UNITED STATES PATENT AND TRADEMARK OFFICE
CERTIFICATE OF CORRECTION

PATENT NO. : 7,102,887 B2
APPLICATION NO. : 10/764592
DATED : September 5, 2006
INVENTOR(S) : Donald A. Blackwell

Fig. 1

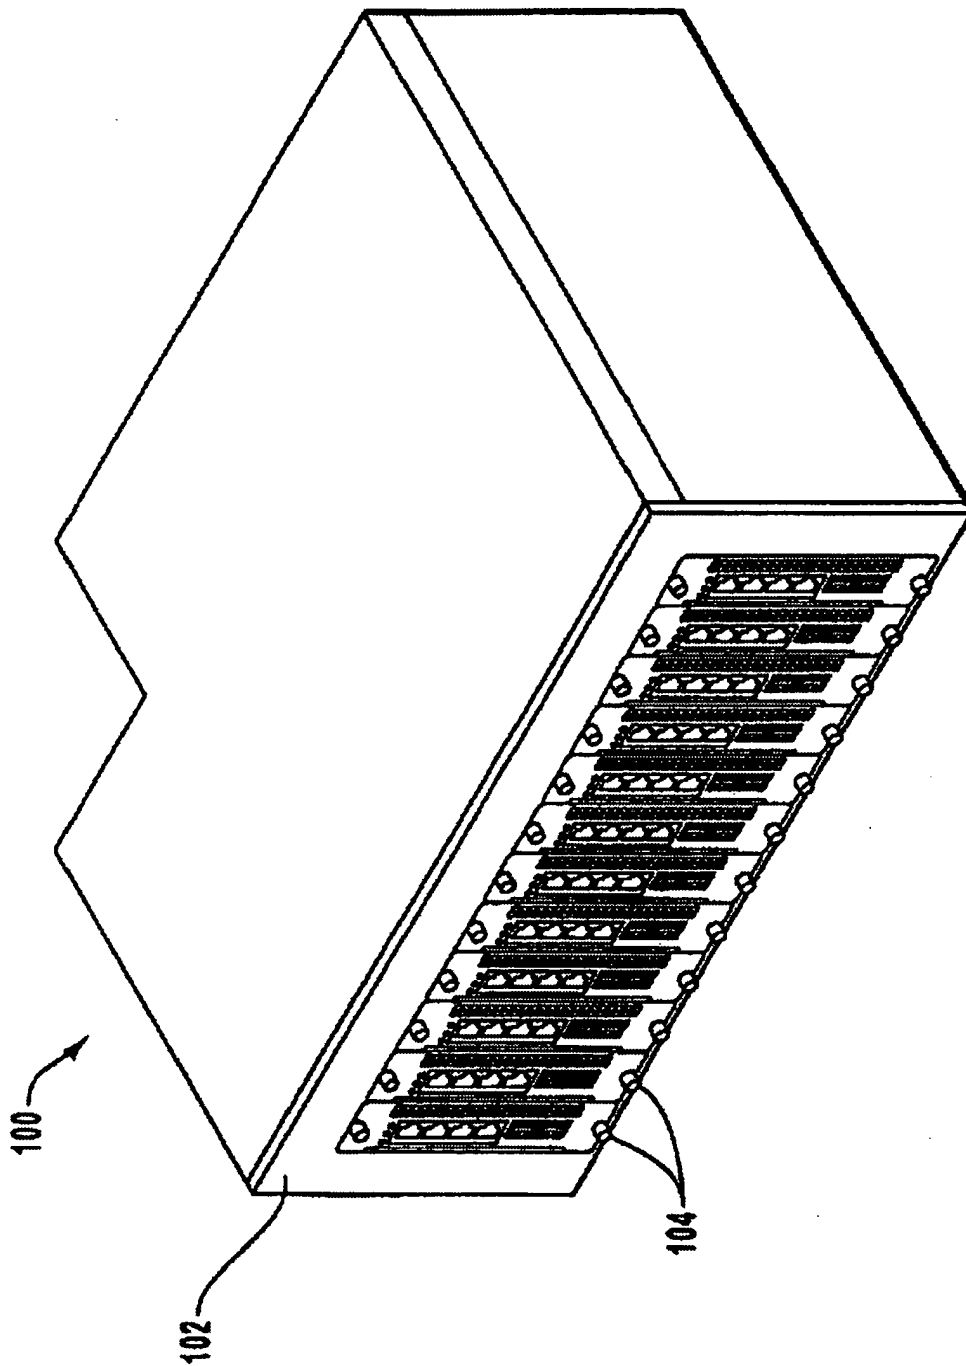
Delete Drawing Sheet 1 of 17 and substitute therefor the attached drawing Sheet 1
